Agenda
Village of Arlington Heights
Design Commission
Buechner Room, 1st Floor

Arlington Heights Village Hall
33 S. Arlington Heights Road
Arlington Heights, IL 60005
June 27, 2017
6:30 PM

MINUTES OF
THE VILLAGE OF ARLINGTON HEIGHTS
DESIGN COMMISSION MEETING
HELD AT THE ARLINGTON HEIGHTS MUNICIPAL BUILDING
33 S. ARLINGTON HEIGHTS RD.
JUNE 13, 2017

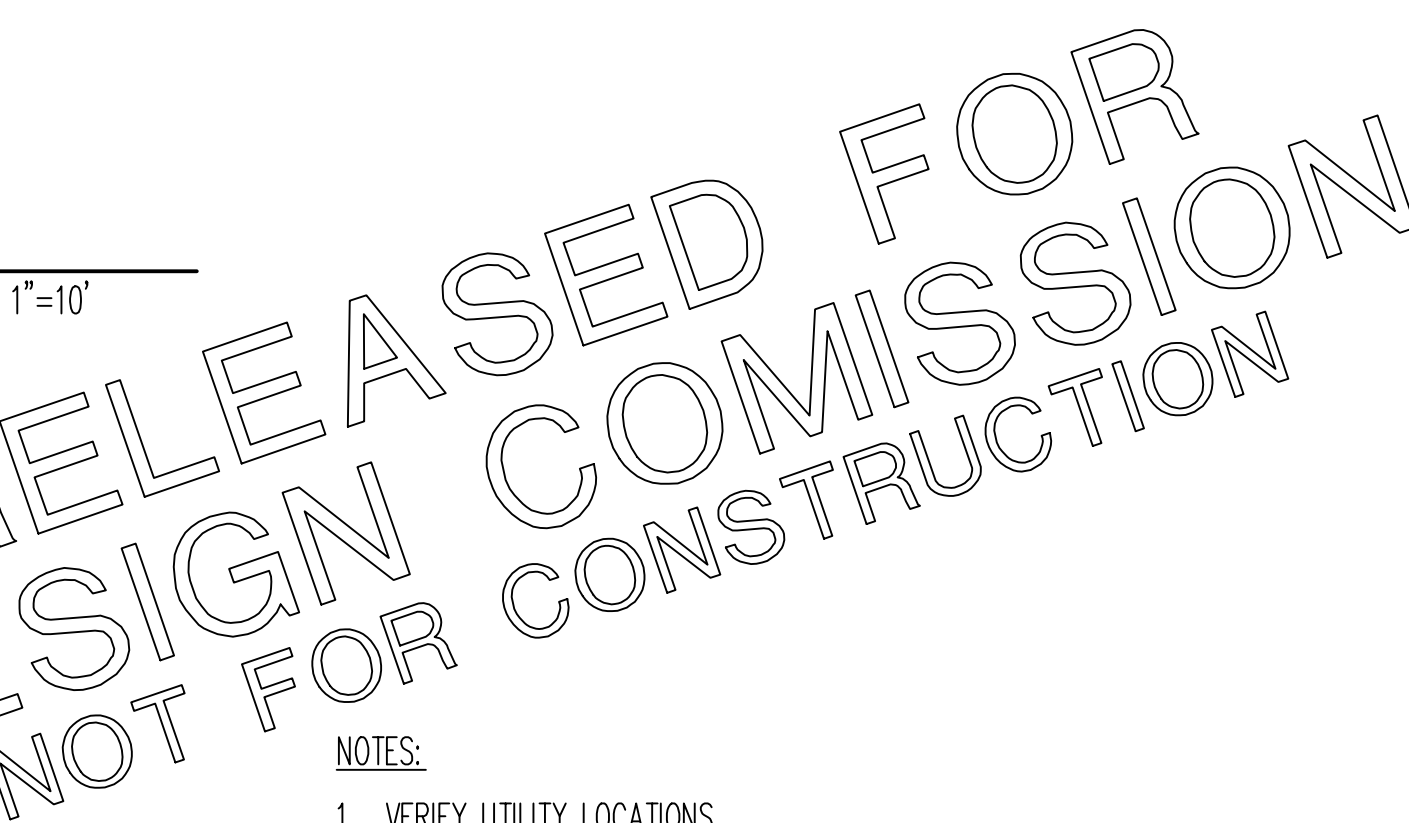
1. Revise the front elevation with a continuous second floor eave, two standard size windows equally spaced with decorative window shutters.
2. This review deals with architectural design only and should not be construed to be an approval of, or to have any other impact on, any other zoning and/or land use issues or decisions that stem from zoning, building, signage or any other reviews. In addition to the normal technical review, permit drawings will be reviewed for consistency with the Design Commission and any other Commission or Board approval conditions. It is the architect/homeowner/builder's responsibility to comply with the Design Commission approval and ensure that building permit plans comply with all zoning code, building permit and signage requirements.
3. Compliance with all applicable Federal, State, and Village codes, regulations and policies.
